DEVELOPMENT REVIEW BOARD MEETING

2. **Resolution No. 436 OrePac Site**

**DEVELOPMENT REVIEW BOARD
RESOLUTION NO. 436**

Exhibit A1
Staff Report
Wilsonville Planning Division
OrePac Site Improvements
Development Review Board Panel 'A'
Quasi-Judicial Public Hearing

L1.10

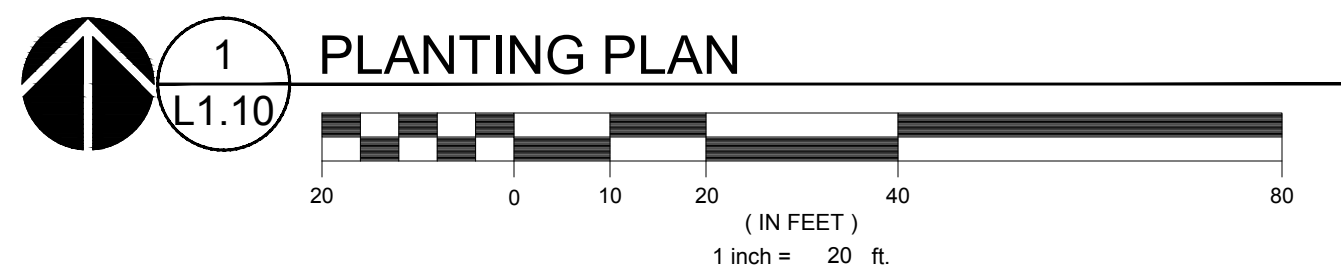
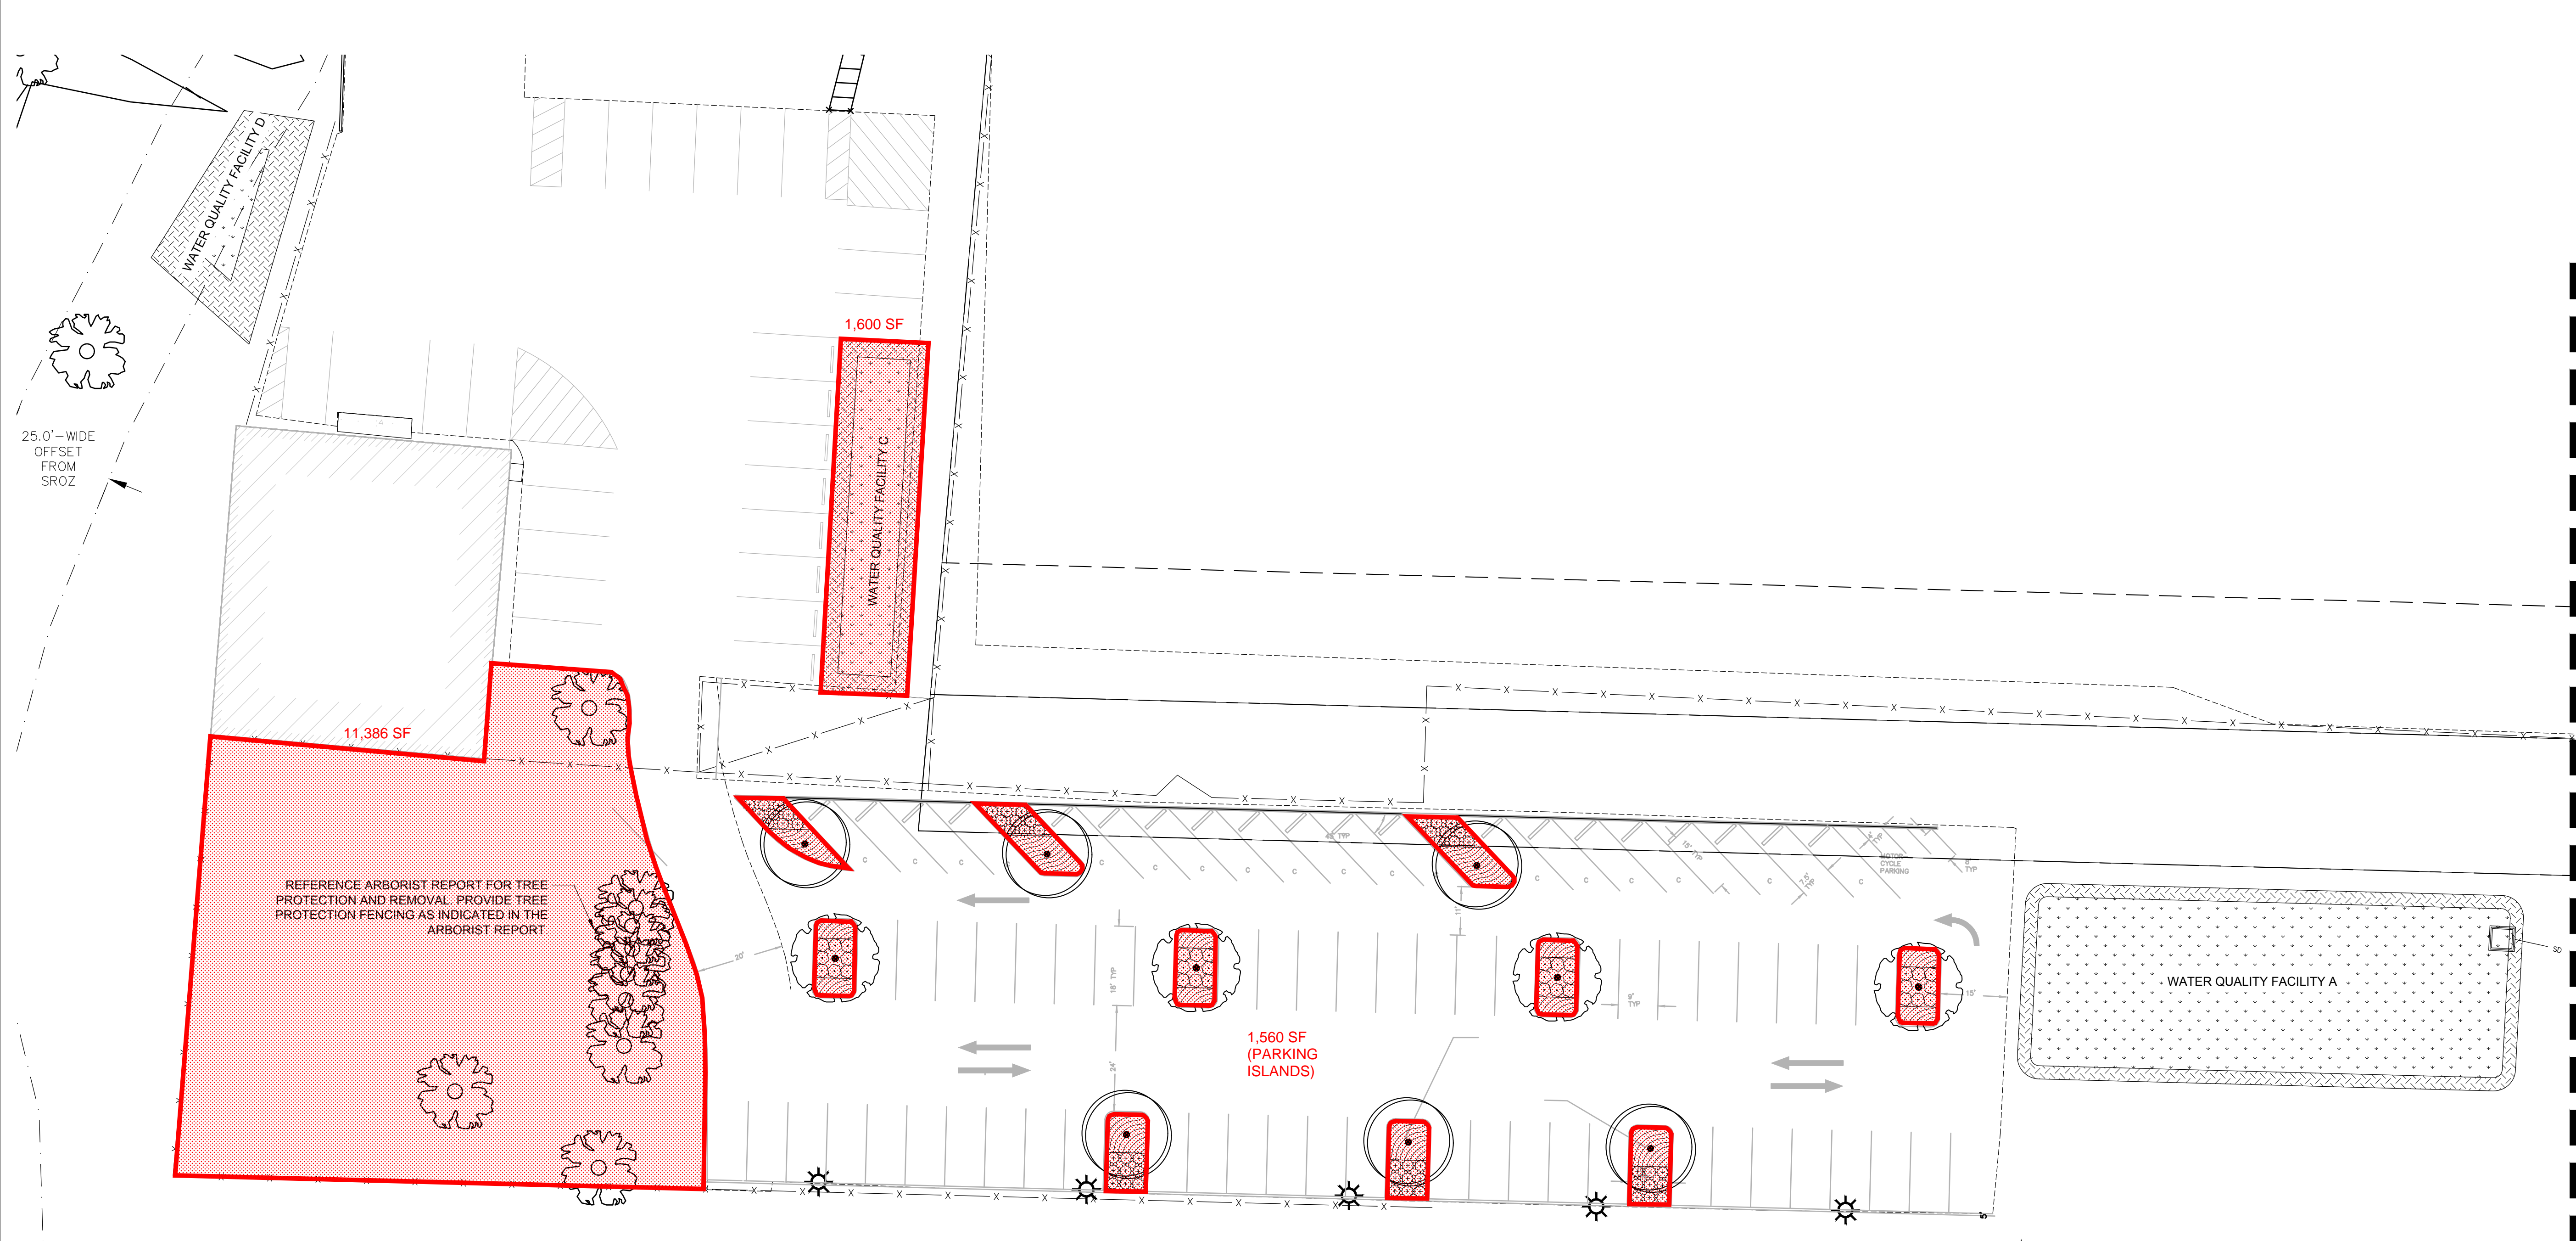
- Parking Lot Landscaping – Section 4.155 (.03) B.: Why are there no landscape islands or landscaping proposed (Sheet L1.10) in the new northern parking area? Are existing trees along the north and east sides being considered parking lot landscaping? [That is correct, the areas in blue boxed in the image below are considered as landscape islands and are provided at an aggregate from the northern parking lot area. The impervious area of the L-shaped parking area is ~15,850 SF, and approximately ~5,200 SF of parking area landscaping is provided, satisfying the 10% requirement. These areas have mature trees which will provide shade to the parking area. Additionally, the new storm facility in the northern parking area is a vegetated facility that can provide similar landscaping qualities.](#)
